1704 Latton Water Treatment Works Tender Change Control Tracker

Issue 01 - 25 April 2025 (work in progress issue)
Issue 02 - 02 May 2025
Issue 03 - 02 May 2025

project	1704	project	Latton Water Treatment Works
document	D07 - 03	title	Tender Change Control Tracker
issue date	02/05/2025	scales shown @ A3

8. Lab and bottle store shown as 30 mins protected enclosure including upper floor.

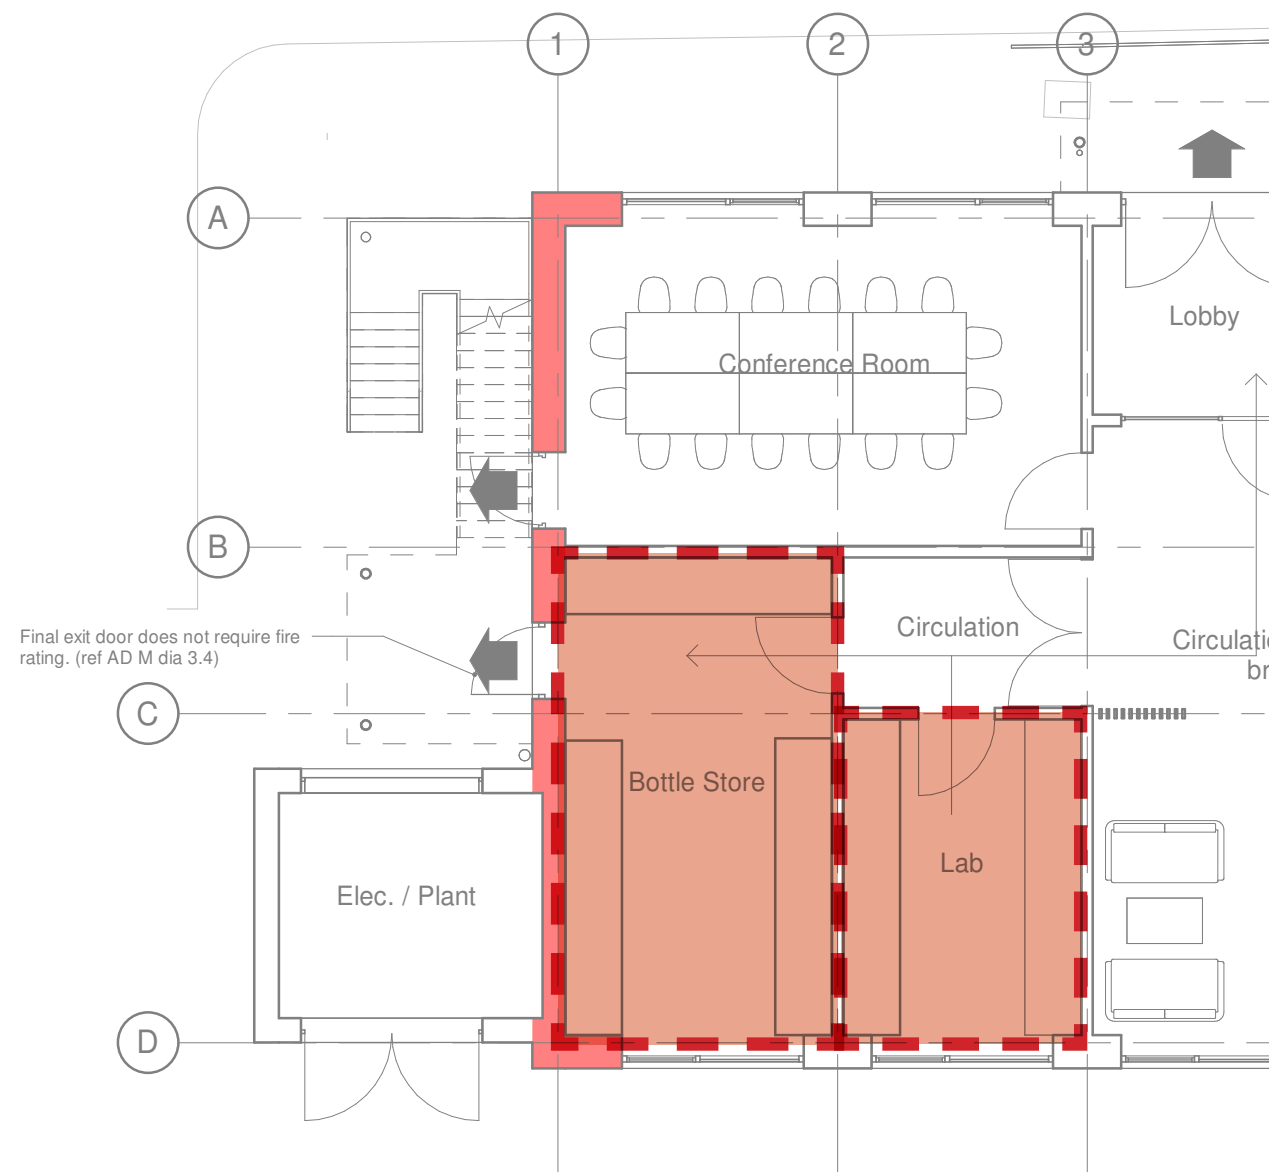
Potential amentment
01. Compartmentation lines added to strategy - enclosing walls largely provide the required separation - firestopping may need to be added.

Reason for change
Suggested by fire engineer.

Design decision
Confirmed 25/04/2025.

9. Compartmentation to external wall above plant room not required.

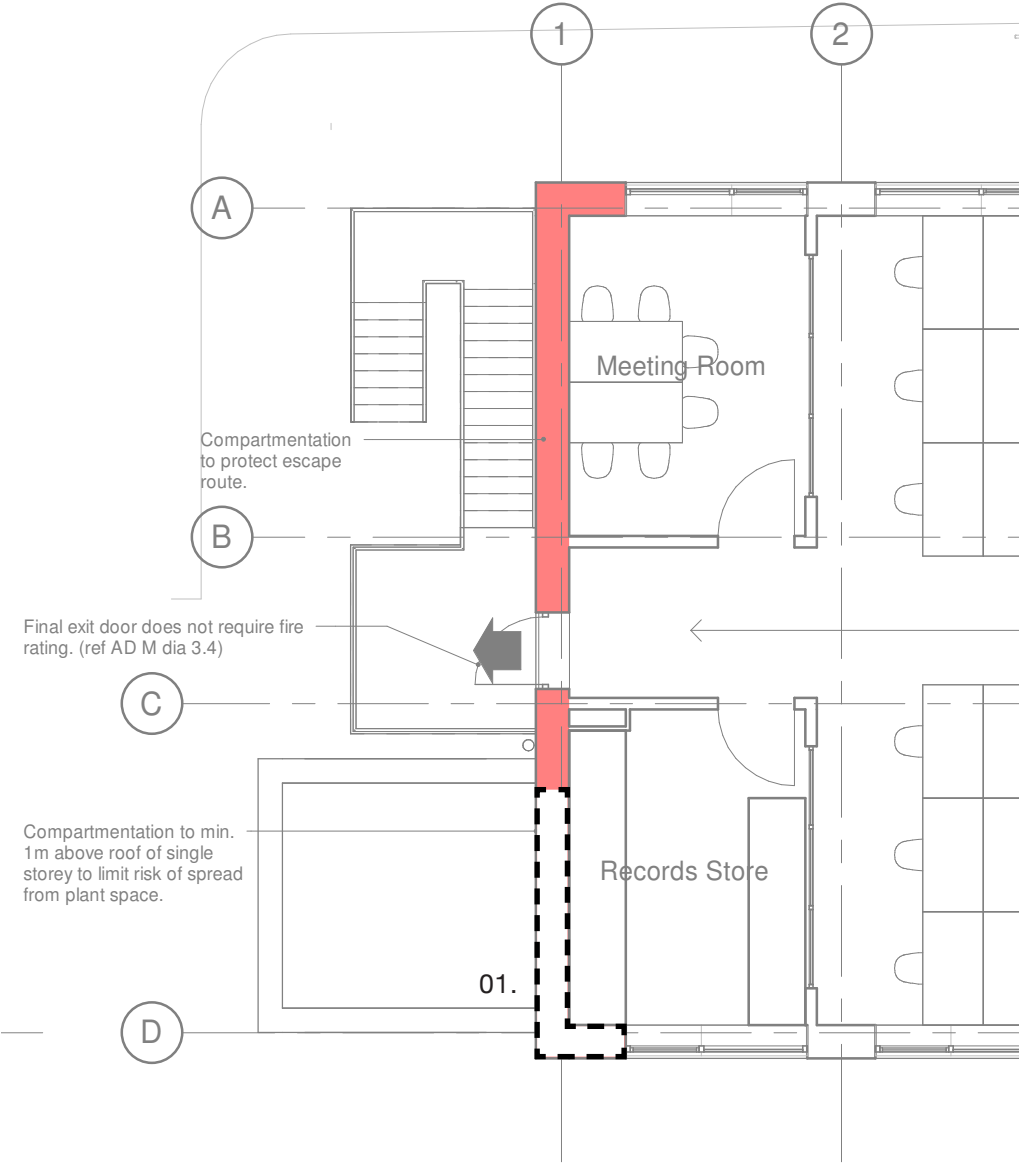
01. Removal of compartmentation indicated on first floor of fire strategy, grid line 1. No material change to building fabric other than localised firestopping.

Suggested by fire engineer.

Agreed to omit, 25/04/2025.

10. Update fire cavity barriers on elevation.

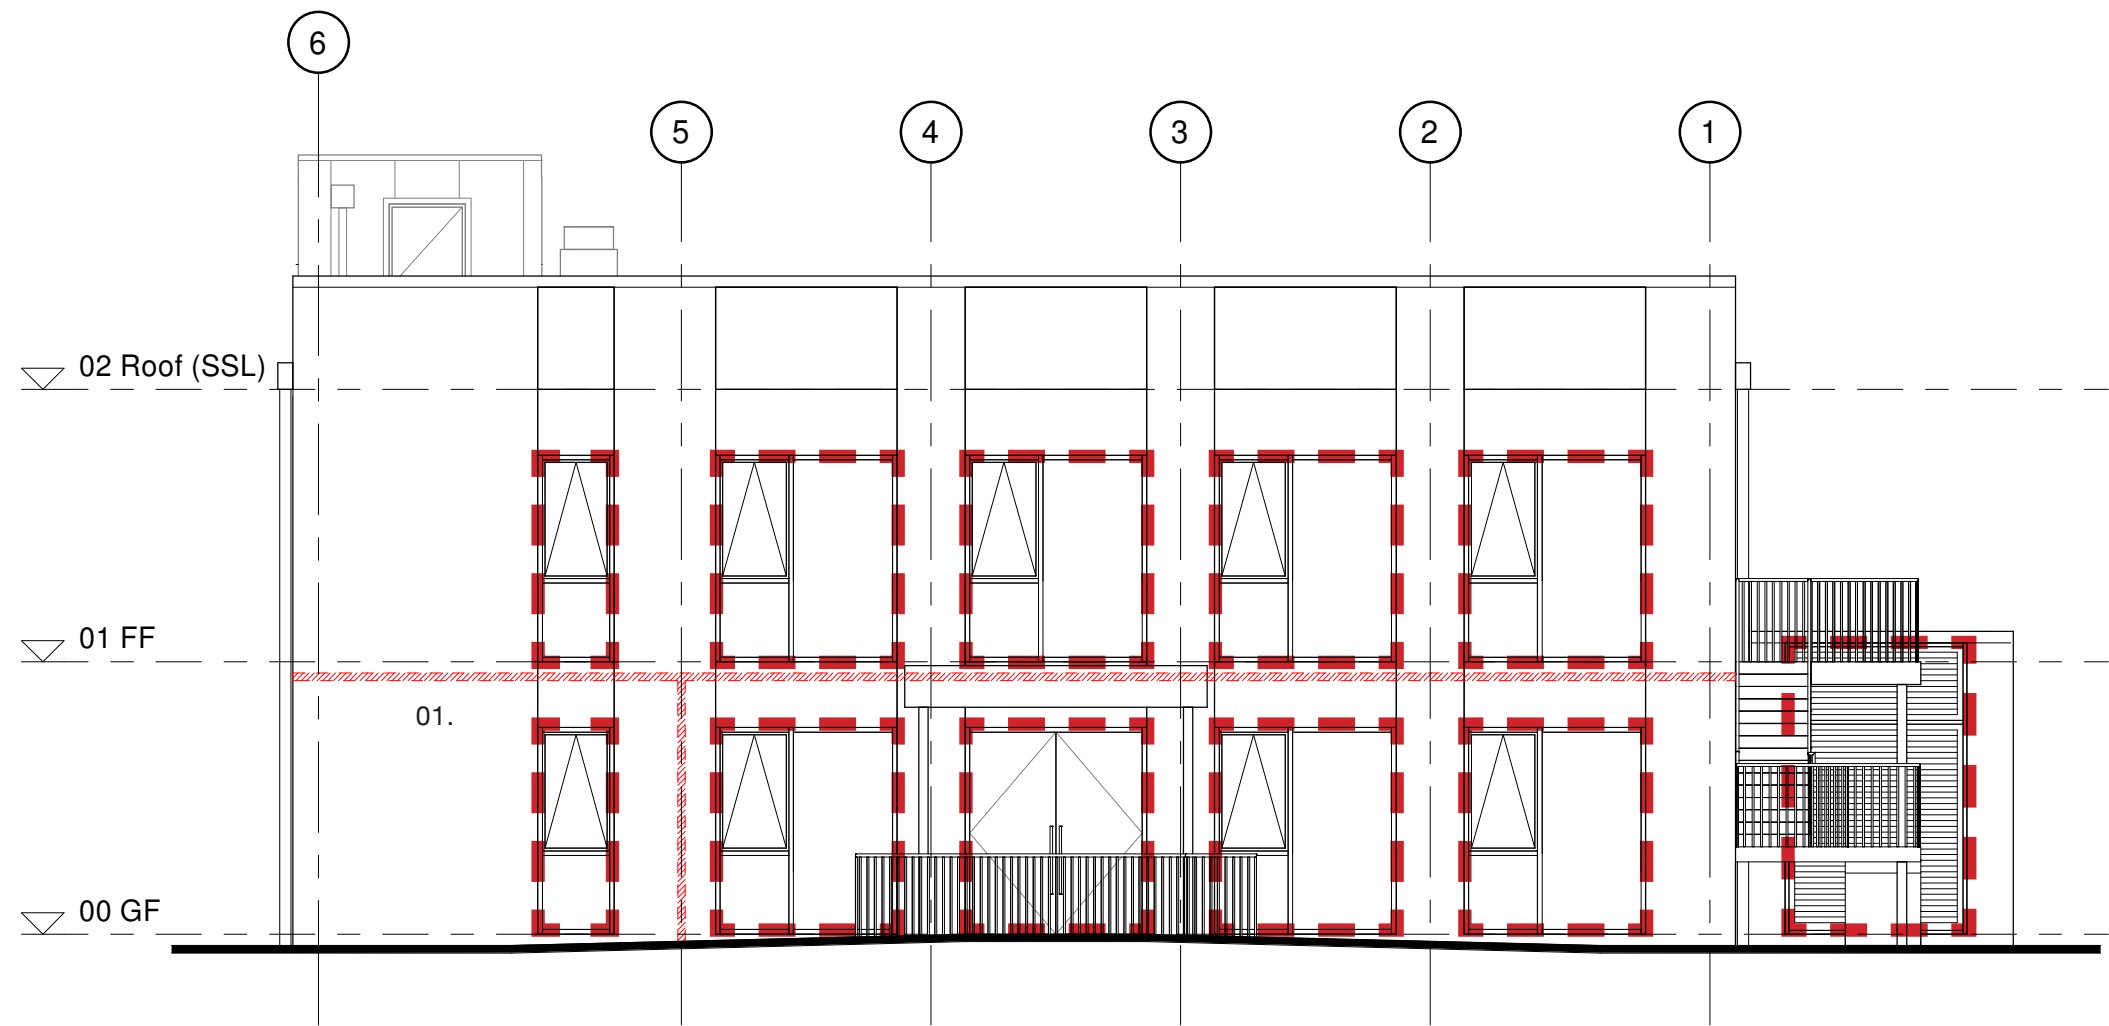
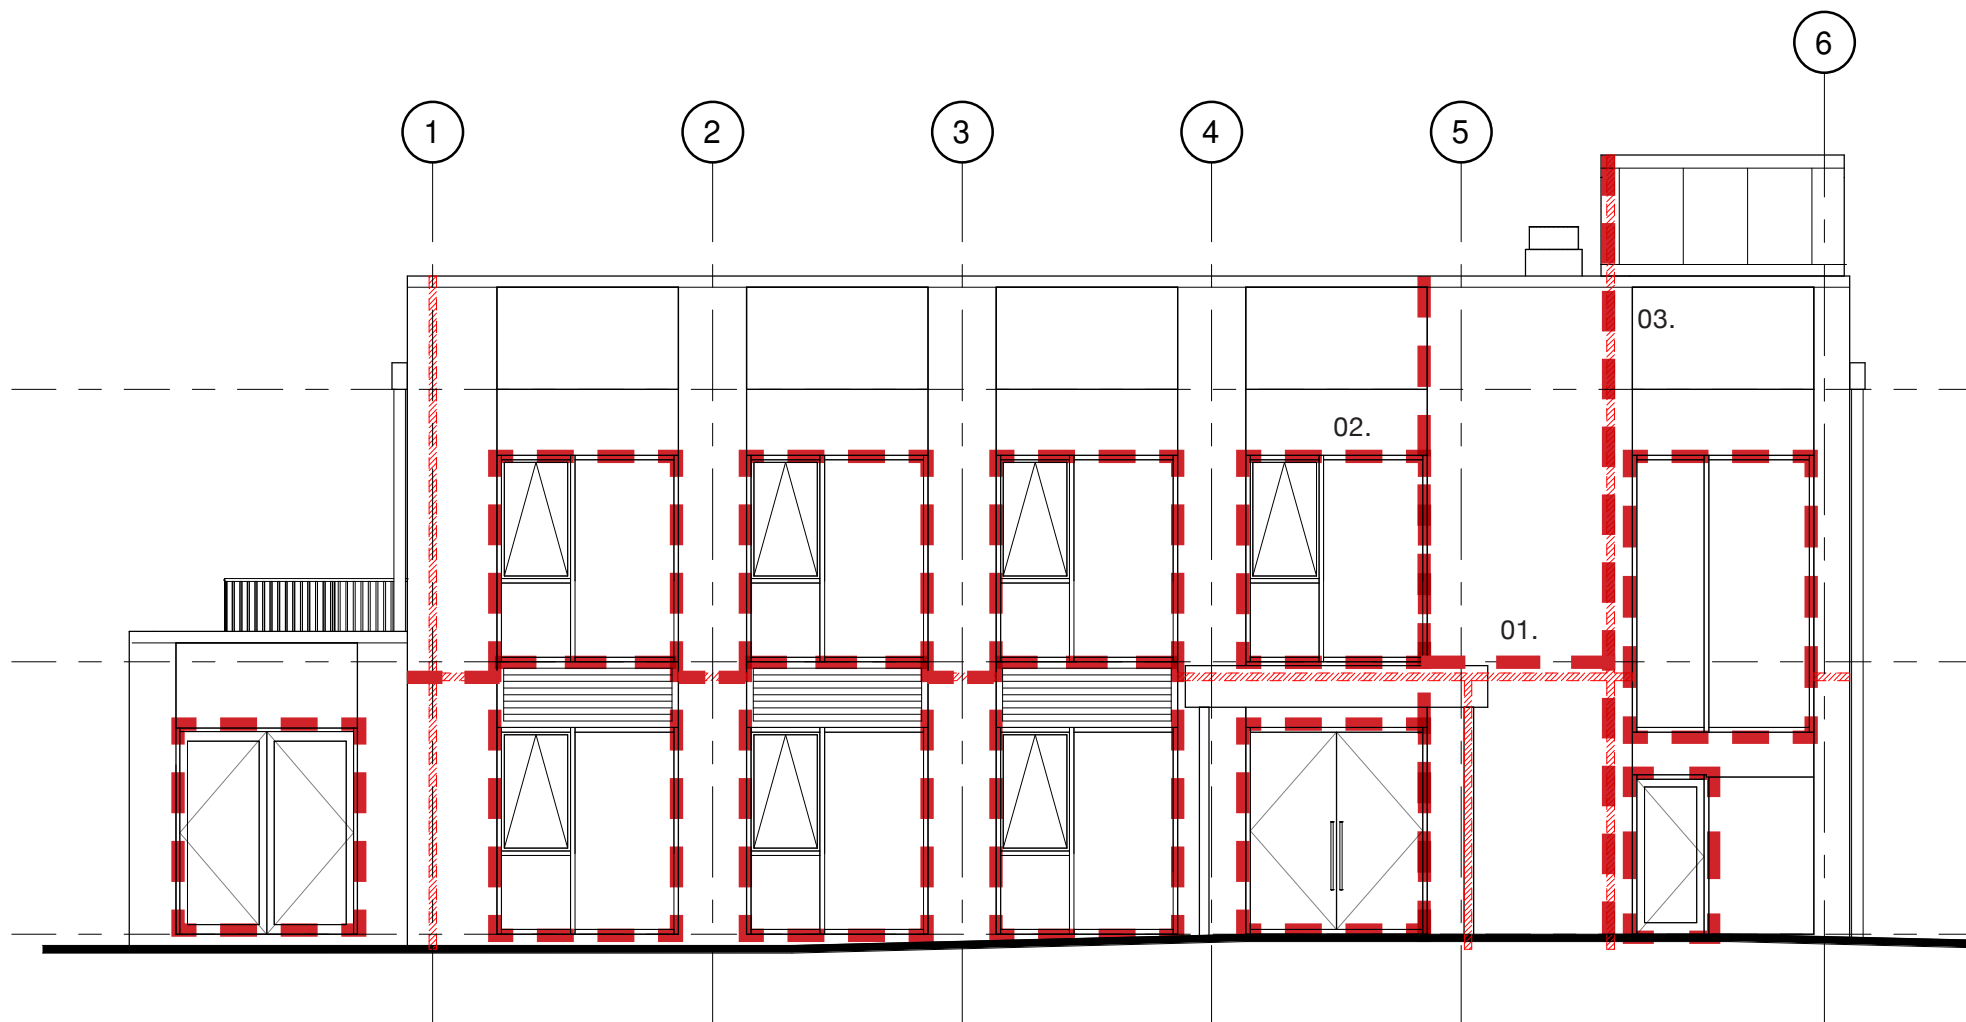
01. Compartmentation not required between floors except to higher risk spaces (store and lab).

- 01. Compartmentation not required between floors except to higher risk spaces (store and lab).
- 02. Firestopping around glazed openings to be indicated - detail to be provided by ICF supplier.
- 03. Openings to protected stairway to be clarified with fire engineer.

Change agreed 25/04/2025.

11. Roof build-up to be updated to Broof(t) standard in accordance with manufacturer’s certification.

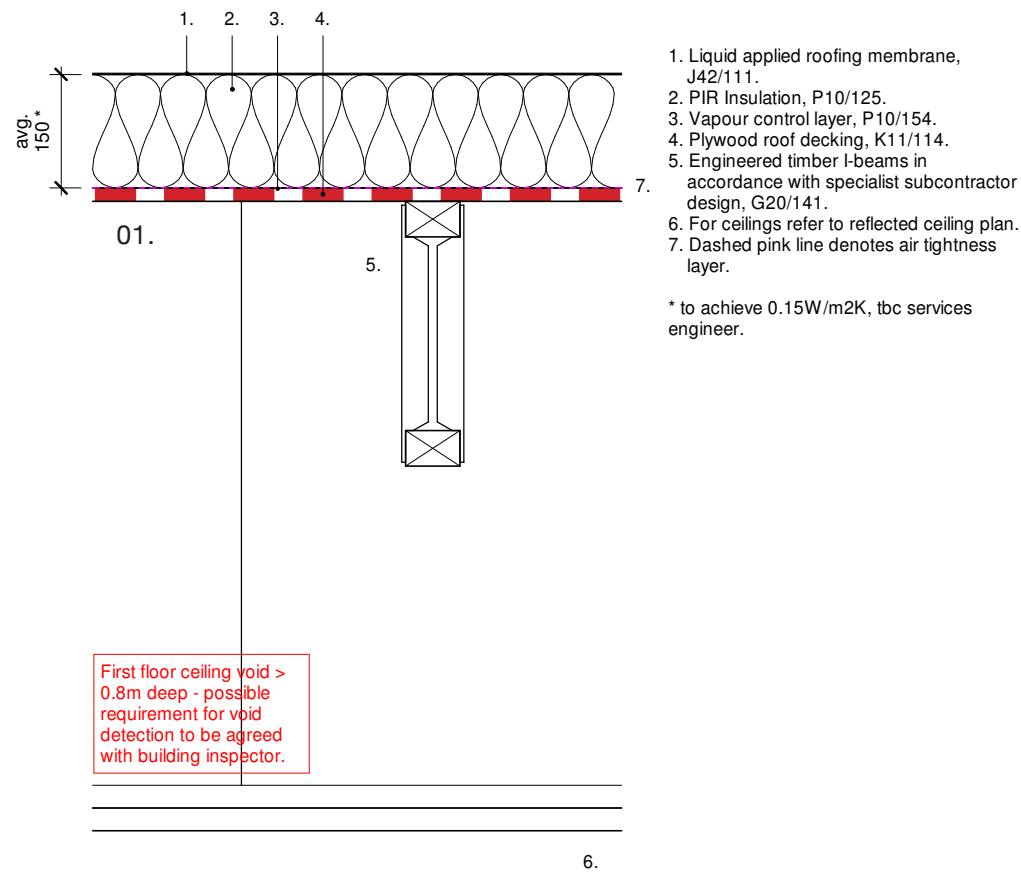
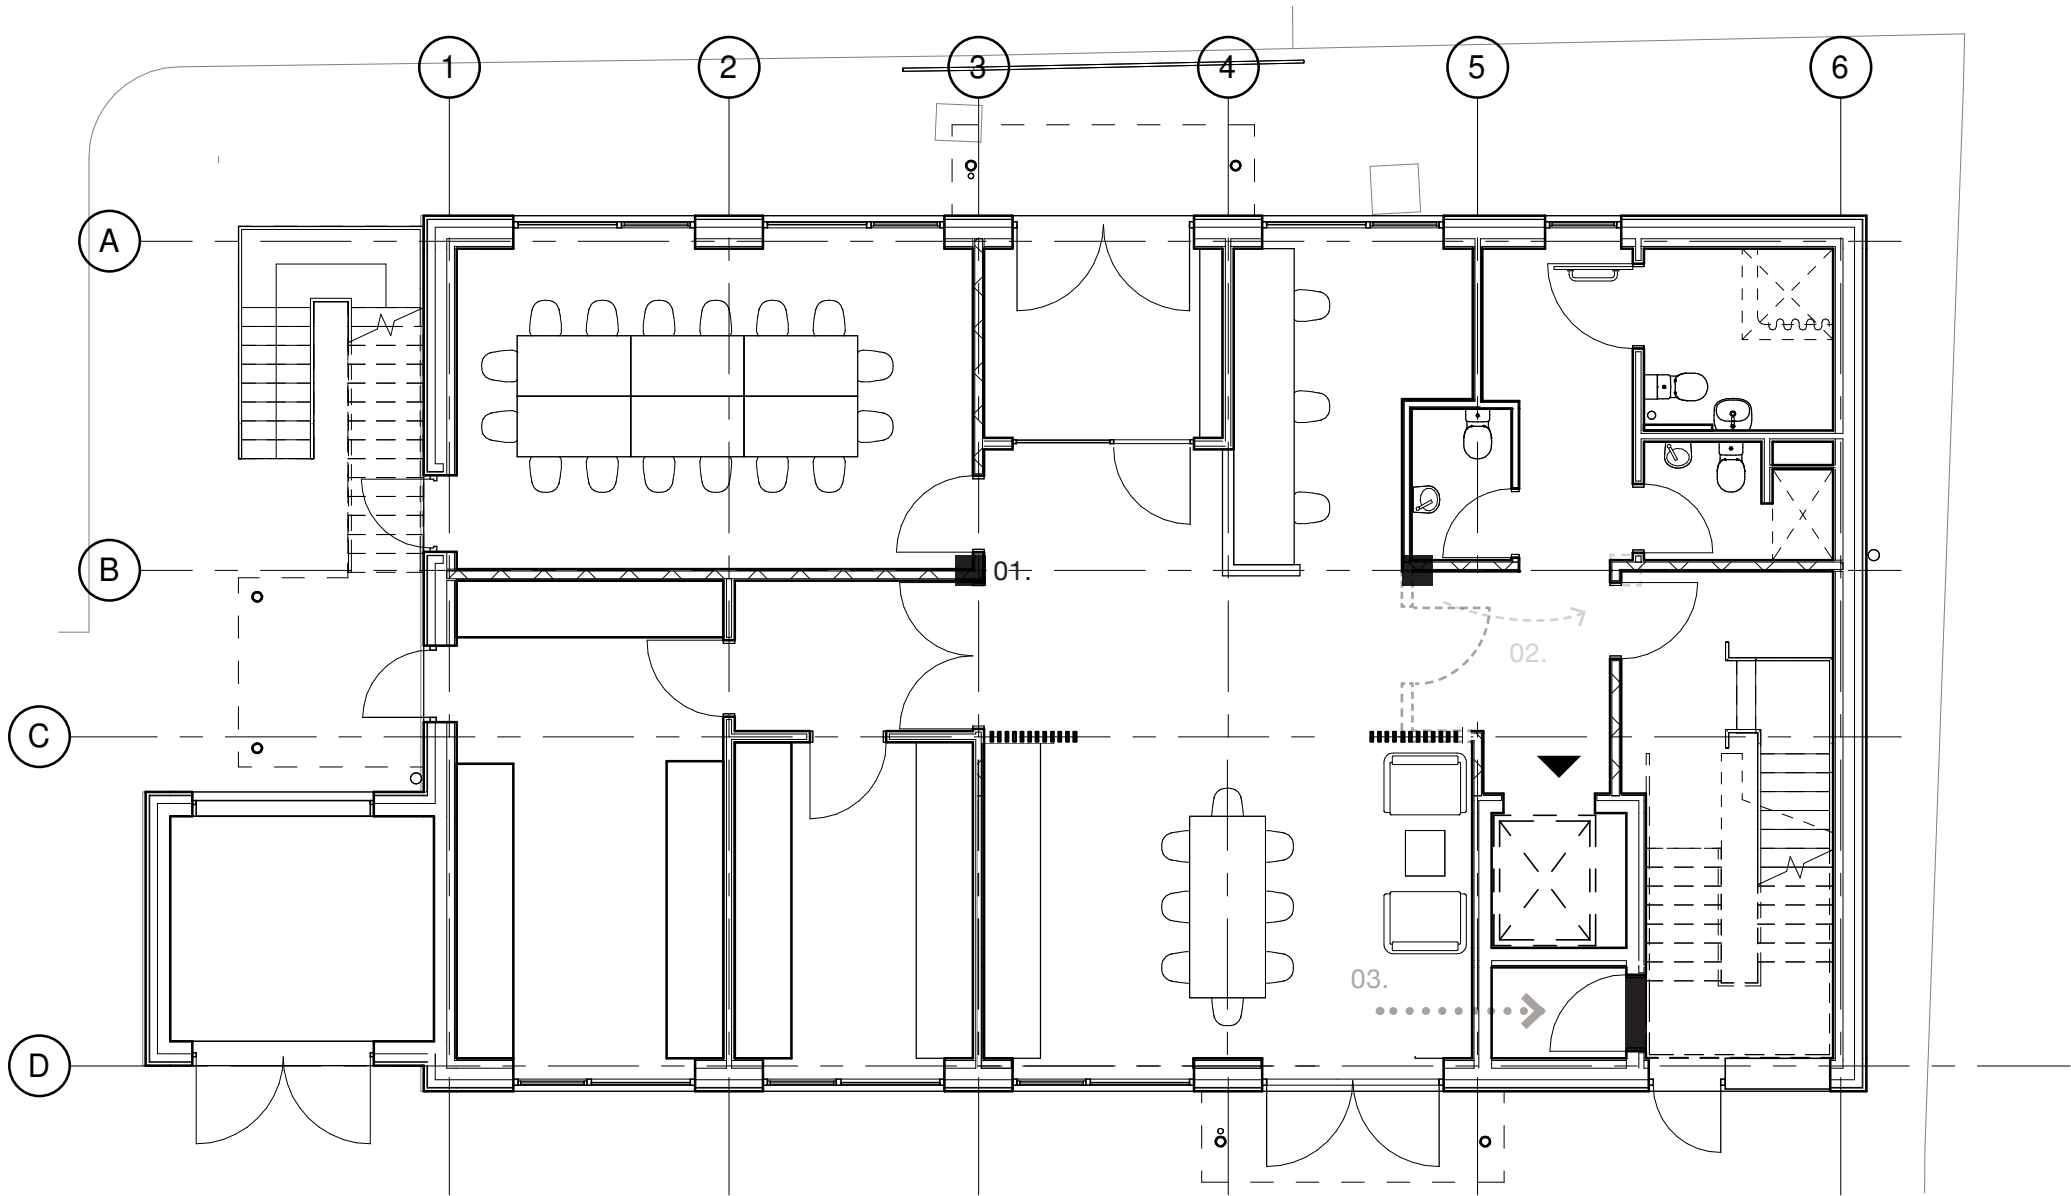
01. To be confirmed by supplier - plywood roof decking may not be suitable.

Suggested by fire engineer.

Plywood decking to be retained, changed to 18mm. Detail and specification to be updated to match updated details (eg. bituminous VCL), agreed 02/05/2025
